**ST. TAMMANY PARISH SCHOOL BOARD
COVINGTON, LOUISIANA**

ADDENDUM 2

**BID #1898 – RENT/LEASE OF MODULAR
BUILDINGS FOR ABITA SPRINGS ELEMENTARY
October 6, 2026**

Questions and Corresponding Answers

E0.01

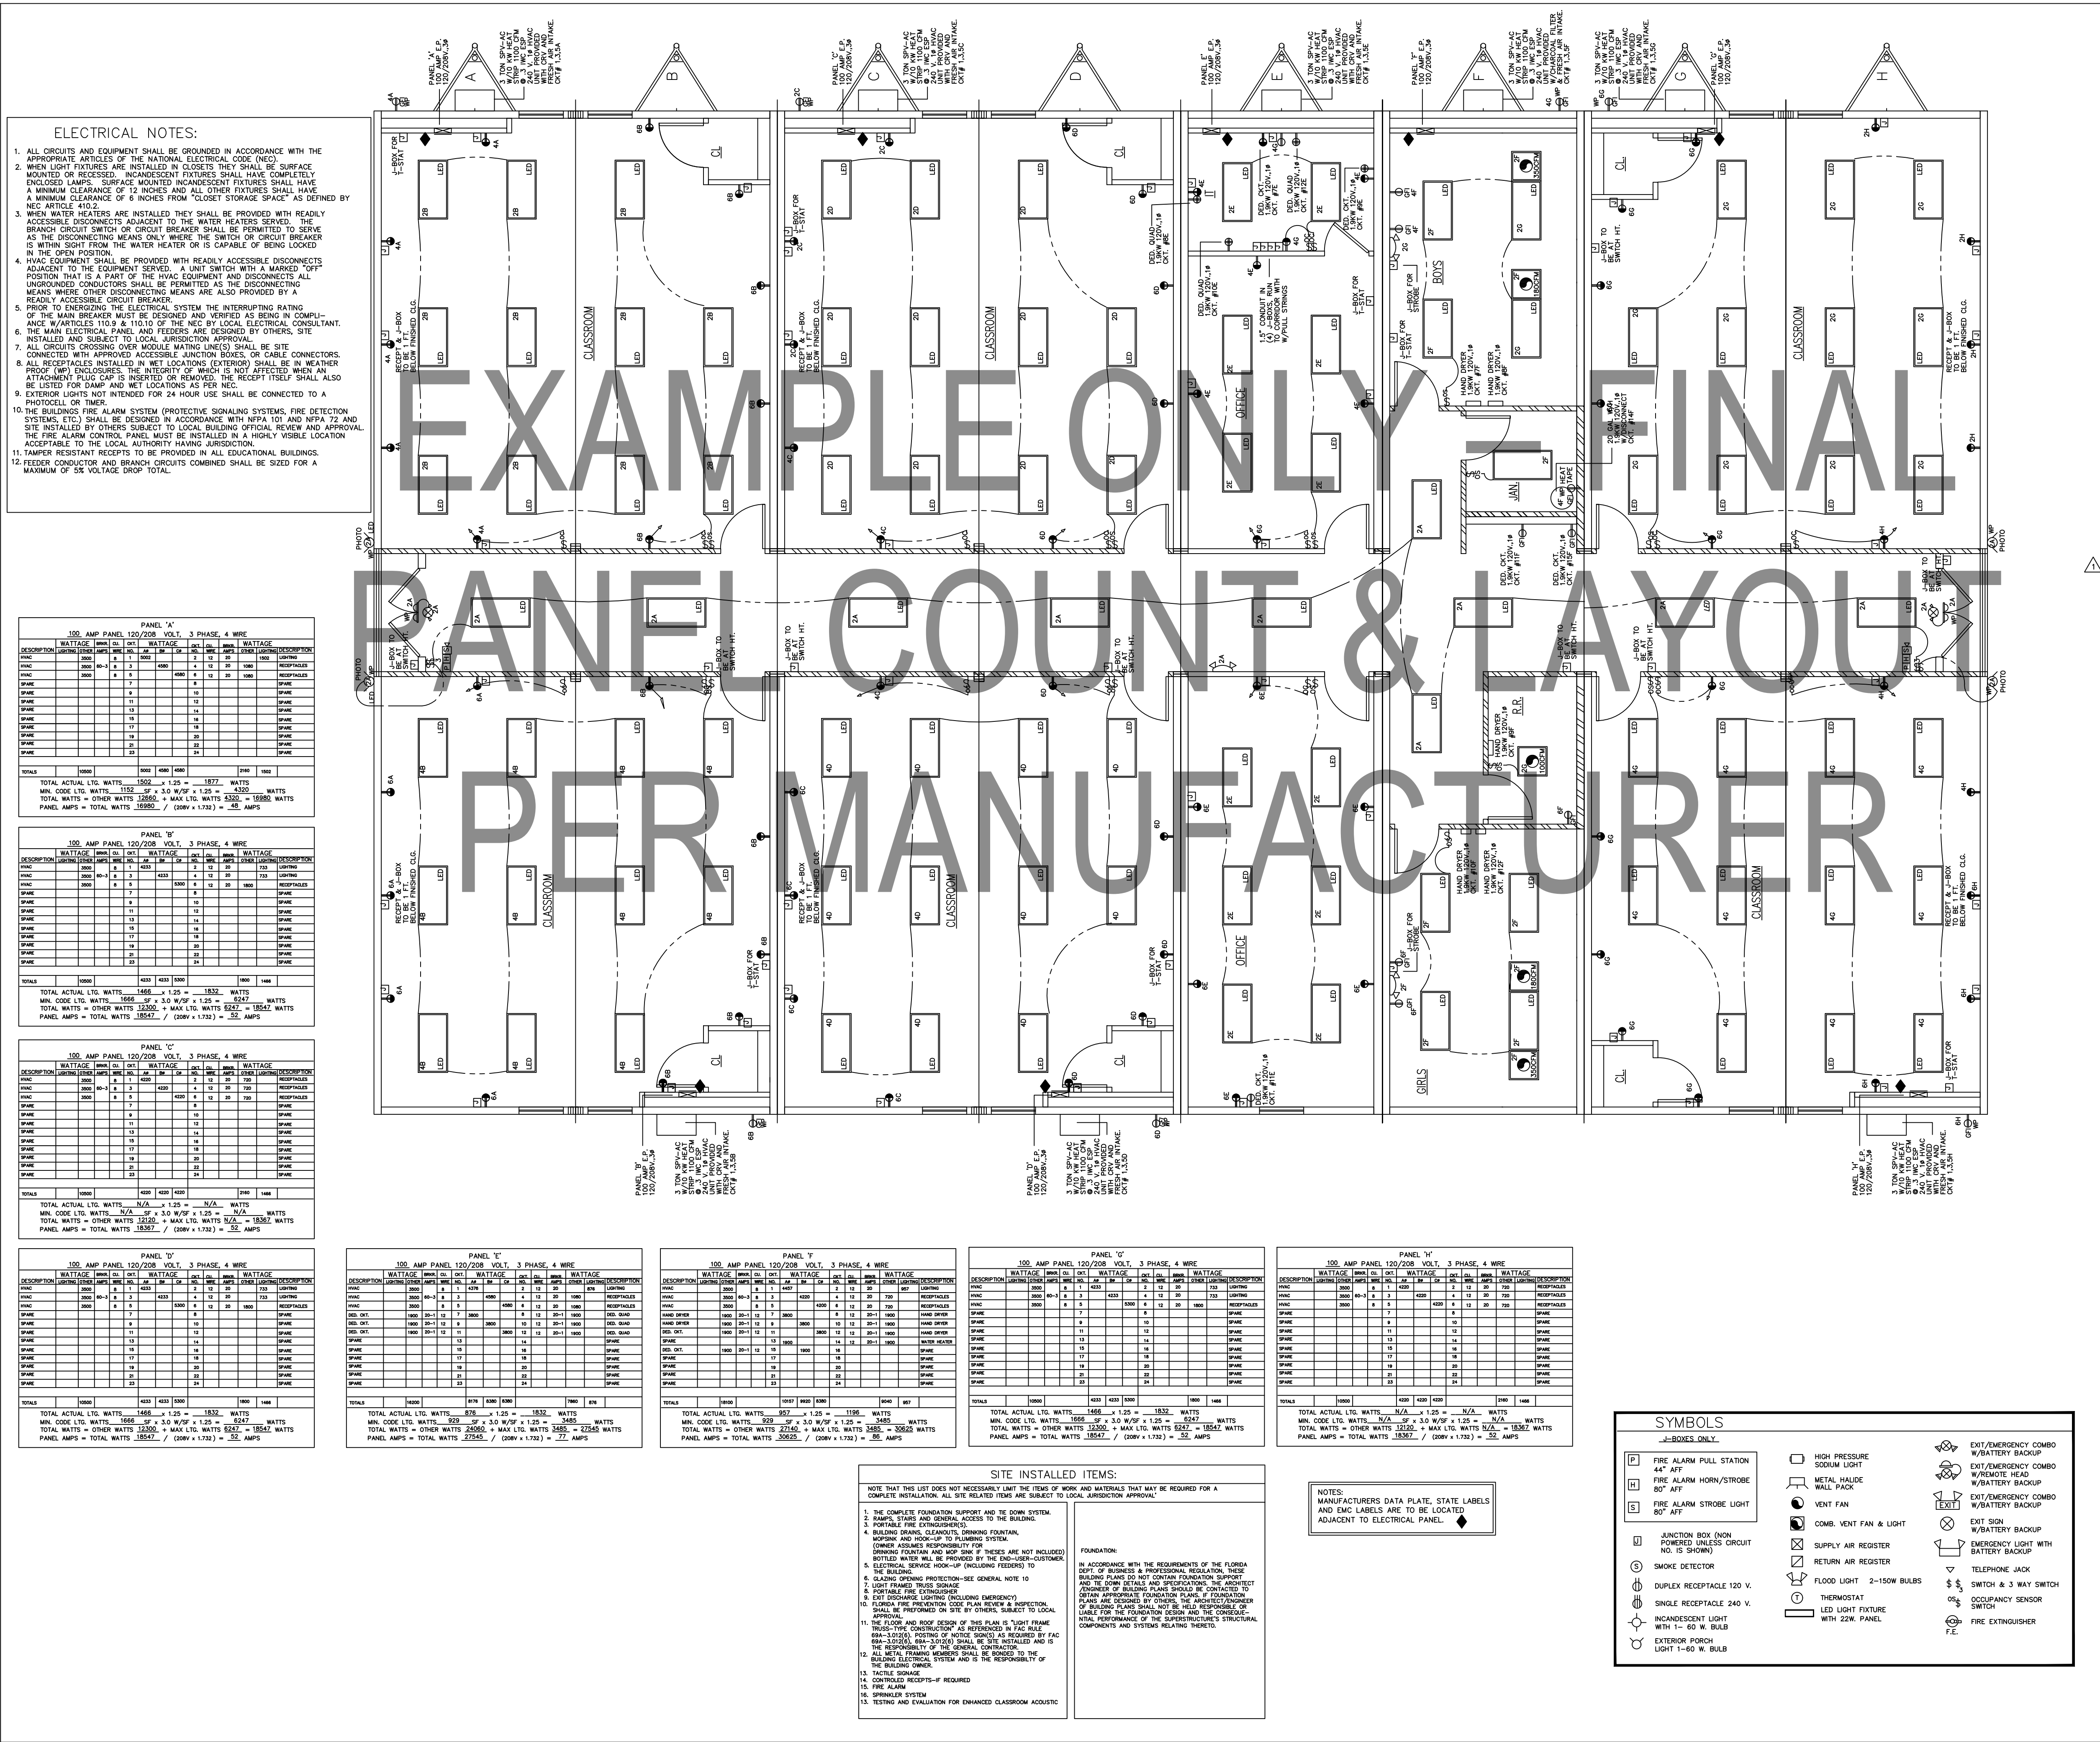
15	Foundation / Site	Site Readiness Before Mobilization	A1.00 Demo Notes D01–D03, D09; E0.01; A2.05 Foundation Note 8	<p>Please confirm the following will be complete by the Infrastructure Contractor/Owner before modular mobilization: tree removal (D01); light pole removal (D02); wheel stop removal (D03); fence removal (D09); storage shed demolition (E0.01); and pad preparation per Foundation Note 8 (grass/debris removed, graded within 6", compacted, positive drainage away from and beneath the building).</p>

A15. A separate contractor and contract for Infrastructure will address tree removal, light pole removal, wheel stop removal, fence removal, storage shed demolition, and site preparation in coordination with and ahead of modular contractor mobilization on site.
16	Logistics	Delivery and Set Logistics	Access Drive exhibit; M1.01 (crane clearance); A2.00 (Cleco access); Spec narrative (school hours/holidays)	<p>Please confirm: (a) crane set is acceptable and crane position (M1.01 "crane clearance" zone); (b) overhead power lines/Cleco pole on the north side – will Owner coordinate de-energizing, line guarding or clearances with Cleco?; (c) allowable delivery/set hours given Magnolia St. is shared with bus traffic, and whether weekend, holiday and Mardi Gras week (Feb 8–12) work is permitted; (d) availability of an on-site staging area for modules awaiting set; (e) whether the affected parking area may be closed during set.</p> <p>A16. Crane set is acceptable. Infrastructure Contractor will be responsible for coordination with Cleco. The overhead line currently feeds the portable building being demolished to prepare the site for the modular placement. Weekend and Holiday work is permitted as long as work times are allowed by Town of Abita Springs. Crane operation during school hours is not permitted. School hours are 8:30 -3:30 M-F typically. The parking lot area immediate to the modular site will not be utilized as a parking lot during the construction period for this project. The driveway and drive loop on the west side will remain in use by the school for busses and deliveries.</p>

E2.00

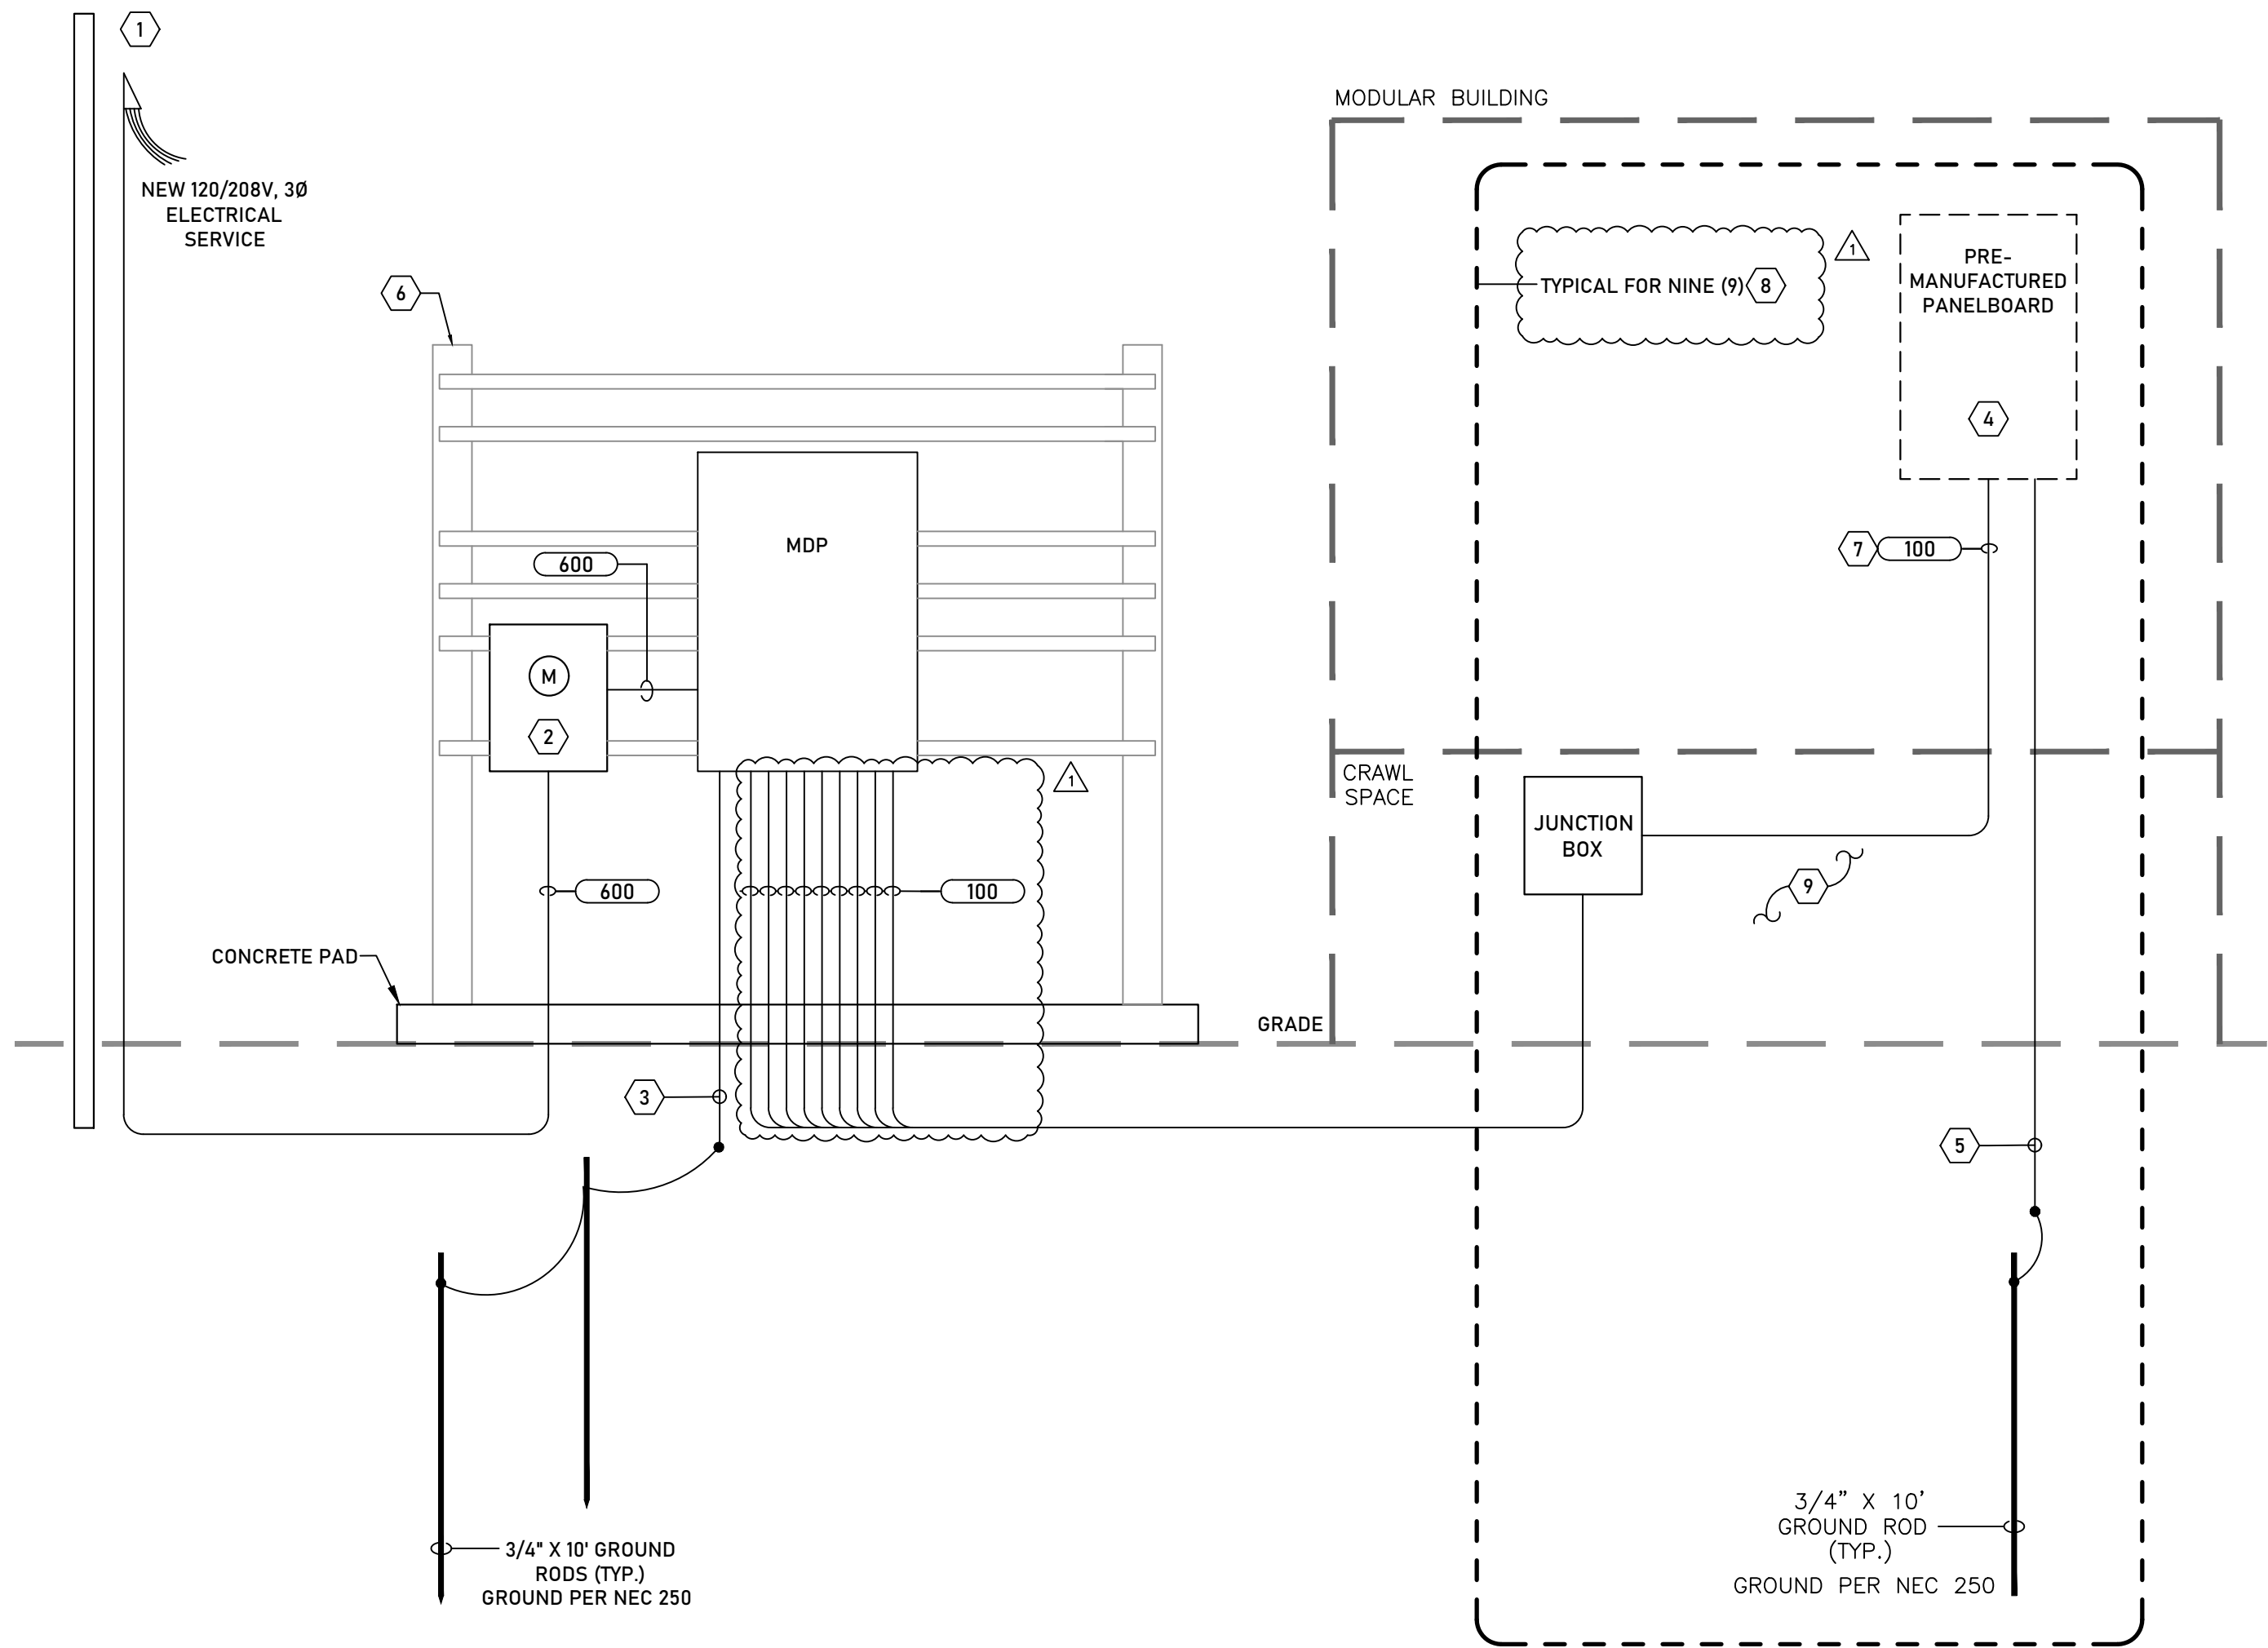
18	Building Systems	Electrical / Low-Voltage Device Responsibility	E2.00; E3.00; Spec 2.2.k	E2.00/E3.00 show devices beyond the spec: numerous dedicated 20A circuits (KN1); HDMI 2-gang boxes at whiteboard and teacher desk (E3.00 Note 1); WAPs, card readers, vape sensors, speakers; F2 exterior wall packs with photocell; EE exit/emergency combos. The spec lists only (32)

<p>empty boxes w/ conduit, (2) porch lights, (3) emergency, (3) exit, (14) occupancy sensors. Please provide a responsibility breakdown. We assume the modular vendor provides rough-in only (box + conduit stub to ceiling) for low-voltage, access control, vape sensor and WAP locations – please confirm quantities/locations. Also confirm: (a) whether the E2.00 fixture schedule applies to the modular or canopies only; (b) target footcandle levels for the required DHH lighting certification letter.</p> <p>A18. All modular buildings should provide all code required and basic outlet locations. Sheet E3.00 Note 1 is for reference to owner provided items that will be installed as part of Infrastructure Contractor's scope. A letter confirming lighting (footcandles) in the classrooms by the lights provided by the Modular Contractor measured at 3' above finished floor will be required in the documents submitted for the project as it is required by Louisiana DHH. Lights shown on Sheet E2.0 are for the walkway canopy and are not part of the Modular Contractor scope of work. An exterior light at the exterior side of the exterior doors at the modular is required in relation to emergency exit. Emergency Exit lit sign with emergency lights are also required on the interior side of the exterior doors of the modular. The Emergency Exit Signs with Emergency Lighting and the Exterior Lights at the Exterior Doors are part of the Modular Scope. See attached Footcandle table.</p>
